## SUMMARY OF CONCERNS IN RELATION TO THE PROPOSED NORTHCONNEX TUNNEL

**This is an objection to many aspects of the proposed NorthConnex tunnel.**

## SECTION A: THE CONNECTIVITY OF NORTHCONNEX SOUTHERN VENTILATION FACILITY AT THE SOUTHERN INTERCHANGE, THE SOUTHBOUND TUNNEL IN PARTICULAR

MOTORWAY OPERATIONS COMPLEX - SOUTHERN VENTILATION FACILITY - SECTIONS  
M1-M2-5000-DR-JD-0525

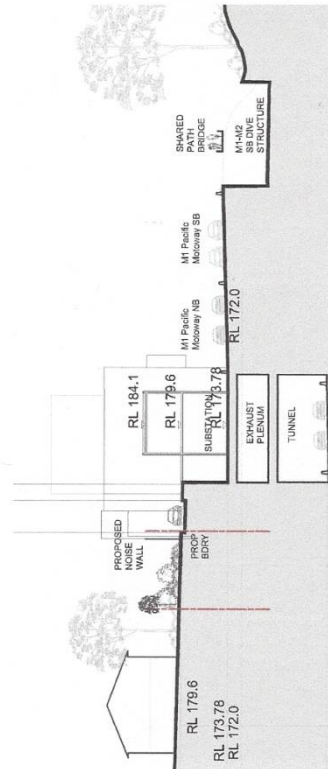
5. *EIS Volume 4, Technical working papers - Urban Design, 6.0 Operational Ancillary Facilities*  
EIS Page 99 there is the diagram "Motorway Operations Complex – Southern Ventilation Facility – sections. *Page 10 below* The diagram has the cryptic label "Connection to tunnel TBC". What does TBC stand for? To be considered? Why is tunnel singular? Which tunnel is the diagram referring to northbound or southbound? There is no diagram showing any connection from the Southern Interchange ventilation facility to either the northbound or the southbound tunnel in any way  
AND YET ....

6. *EIS Volume 4, Technical working papers Urban Design, 8.0 Landscape Design*  
EIS Page 176 is the diagram "Motorway Operations Complex – Southern Ventilation Facility – Site 1-1". *Page 13 below* The diagram does not show any connection to either the northbound or southbound tunnel. In the same Landscape Design section, EIS Page 182 is the diagram "Wilson Road Tunnel Support Facility –Section" *Page 14 below* which clearly shows the connection to the tunnels. In the same Landscape Design section, EIS Page 189 is the diagram "Northern Ventilation Facility – Landscape Concept Section". *Page 15 below* This also clearly shows the connection to the tunnels.

- Diagrams need to be provided showing the inter-relation between the shaft, the ventilation outlet and the motorway operations centre with a clear description of what is to be constructed and how it will operate.
- The community needs irrefutable evidence that the polluted air from the southbound tunnel exit portals will not be allowed to flow like an invisible sewer through West Pennant Hills, North Rocks, Carlingford and Beecroft.

M1-M2-5000-DR-UD-0550  
NORTHERN VENTILATION FACILITY - CROSS SECTIONS

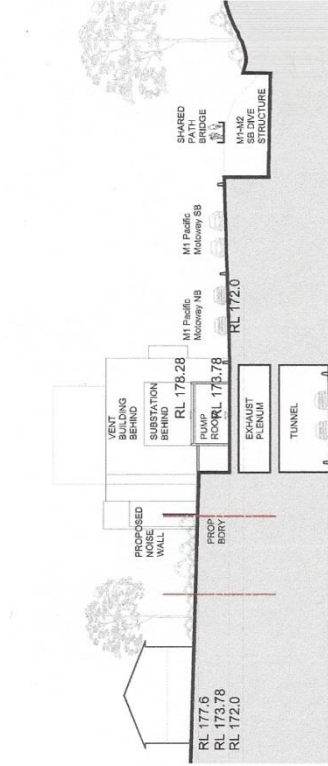
EIS page 135 *Page 11 below* there is a very explicit diagram showing the *Northern Ventilation Facility – cross section*.

EIS page 134 *Page 12 below* there is a very explicit diagram showing the *Northern Ventilation Facility – long section*.
